**Town of Hinesburg  
Planning Commission  
November 14, 2018  
Approved November 28, 2018**

**Official Map Revisions:**

Hinesburg Official Map  
DRAFT REVISIONS

**DRAFT 5**  
**(for community input)**

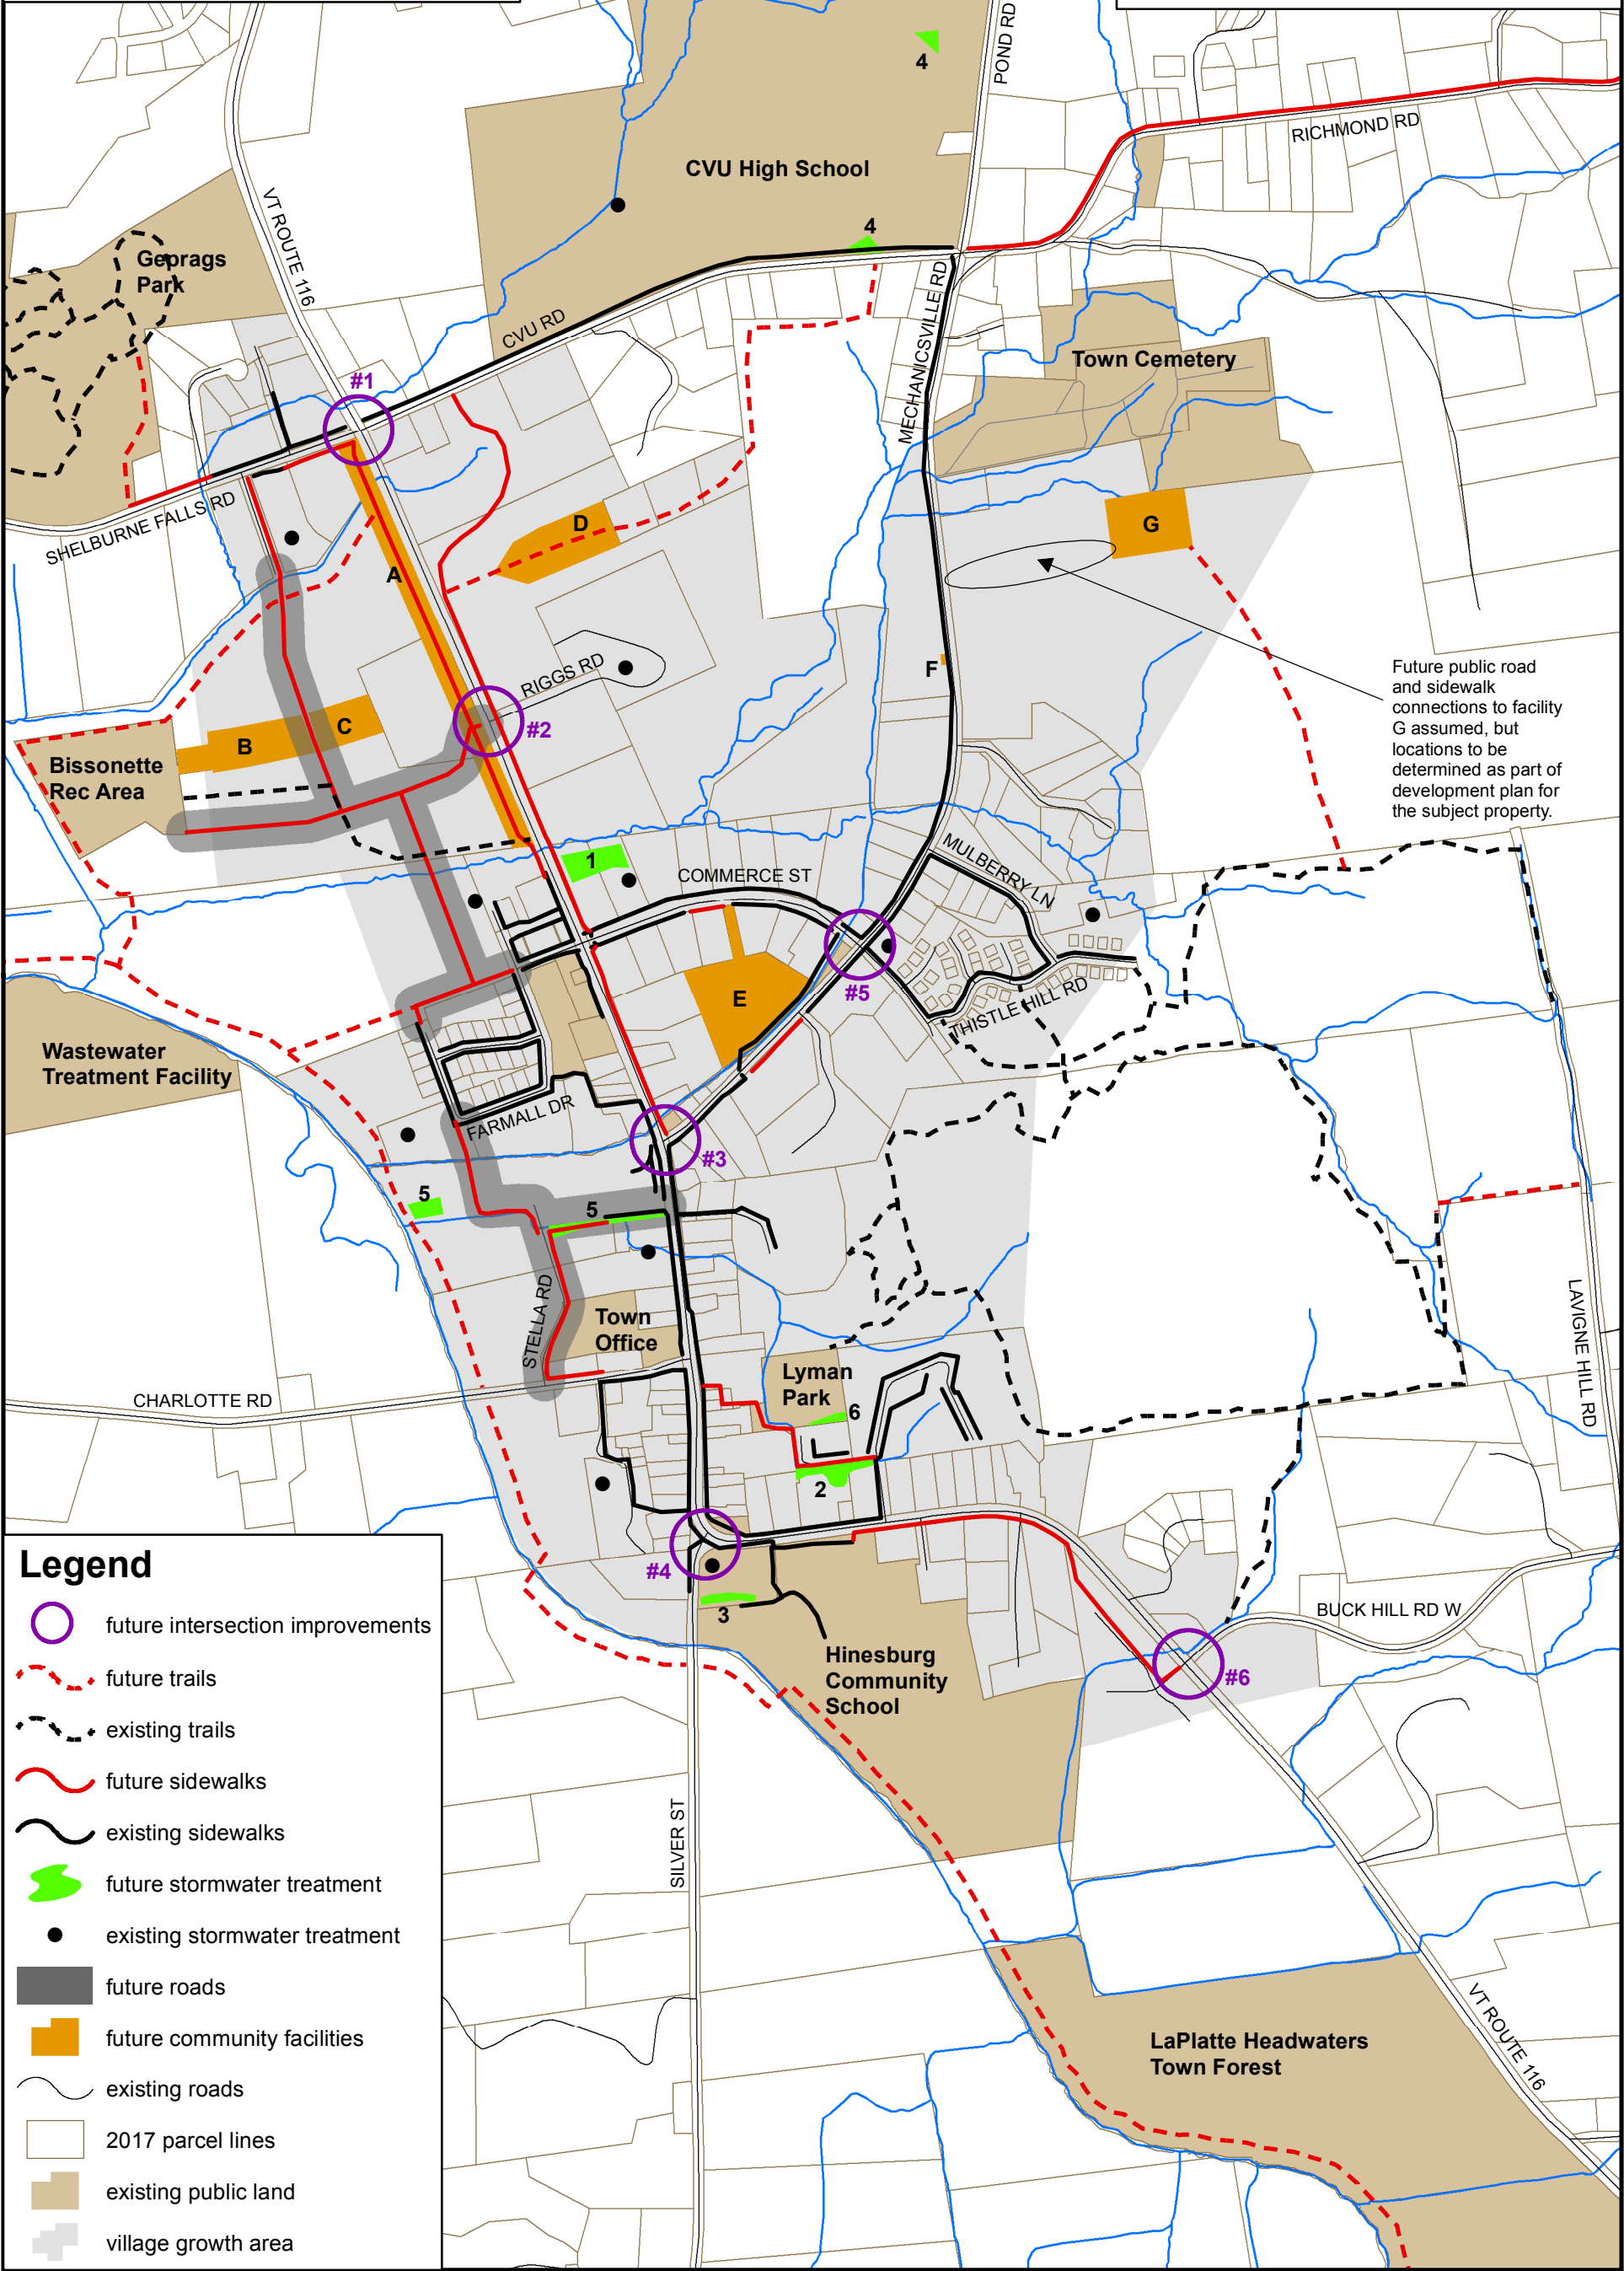
Alex W. said they received correspondence from Lenore Budd (Trails Committee), who recommended adding back Geprag's Park future connection from Ballard's Corner (showing both options). They've been working with the owner of Travia's, and perhaps next owner would be receptive.

Summary of Alex's conversation with John Mead (Hart & Mead): he has concerns with that Official Map element because of potential future development. Alex and John M. walked the swale along the stream on the north side of Hart & Mead, because consultants recommended this as a good location for stormwater treatment. Alex stated that the state does not want to work on treatment within wetland areas. The bulb-out at #2 is a wetland (cattails) – may be difficult to accomplish stormwater treatment here anyways. There is a long culvert from St. Jude's back to that area. John M. stated the culvert wasn't set properly (too high), which has caused water to back up along the Hart & Mead property.

Alex W. suggested a better location might be on Lyman Meadows common land somewhere or in Doug Mead's back yard. Marie G. said it Doug Mead's yard is also very wet. Alex W. said he wouldn't be surprised if it were a wetland if allowed to naturalize. Marie G. would recommend Lyman Meadows – but it would require going uphill to get there.

Alex W. suggested Lyman Park, from #6 south to road. It may warrant a more intensive look. Marie G. recommended a road trip to explore it.

Joe I. recommended putting it sub-surface below parking lots. Church parking lot and Lantman's are both downhill of significant drainage area.

James D. recommended using the northwest corner of Lyman Park. Alex W. said it would be dependent on the state allowing us to divert the stream to pass through a treatment area.

James D. wondered about lower of two fields behind the United Church, unusable as wet as it is. Alex W. replied flood hazard area comes into lower part of soccer field. #1 (behind Mobil station) is also close to Patrick Brook, could potentially be mapped as wetland. Alex W. said he would need to discuss with the state.

Marie G. said it sounded like #2 wouldn't work from what Alex said. John K. asked if this is wetland, and if the state would not allow us to construct here. Alex W. said he would check with state. Barbara F. asked if it has always been a wetland. Maggie G. asked and received clarification on property line location.

James D. **made a motion to move #2 to the northwest corner of Lyman Park.** John K. **seconded** the motion. There was discussion about the size. John K. commented it would not fit in the corner of Lyman Park at the same size. Alex W. replied it would have to be smaller. The Commission **voted 6-0** to move it.

James D. asked about the sidewalk in front of Giroux's. Discussion ensued. Does it have to be raised/marked? Everyone was on the same page, and agreed to add a sidewalk should it be redeveloped.

James D. asked about a sidewalk on east side of Mechanicsville Rd. Alex W. said it came off on this draft (was on old map). Alex W. commented they are removing sidewalks in Essex Jct.; part is based on usage, some is a financial decision. Do we need parallel sidewalks on both sides of the road? There is at least one resident on Hawk Lane wondering why there's no sidewalk connecting their neighborhood. John K. said you'd put a crosswalk where road comes in to neighborhood.

The Commission was ok with adding the sidewalk back in.

Joe I. and others suggested adding second entrance to Geprag's back in. John K. mentioned Andrea M.'s comment about adding a path from Bissonette Rec Fields across to Geprag's.
